### **AMENDMENTS TO THE DRAWINGS**

### REMARKS

Figure 1

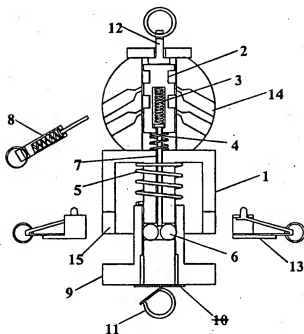
In Figure 1, the upper view has been labeled "A" and the lower view has been labeled "B". Additionally, the reference character "10" has been deleted from the figure.

The Examiner objects to the drawings as failing to comply with 37 CFR 1.84(p)(5) because they include reference characters not mentioned in the description, namely "10" and "11" shown in Figure 1. Applicant has amended the description to indicate what corresponds to reference character "11". Applicant notes that this reference character was inadvertently omitted from the description but the specific item to which it refers was nonetheless clearly described in the text. Applicant has amended Figure 1 to no longer depict reference character "10".

The Examiner objects to the drawings as failing to comply with 37 CFR 1.84(h)(4) because Figure 1 has two views. Applicant has amended Figure 1 to recite each view as "A" and "B".
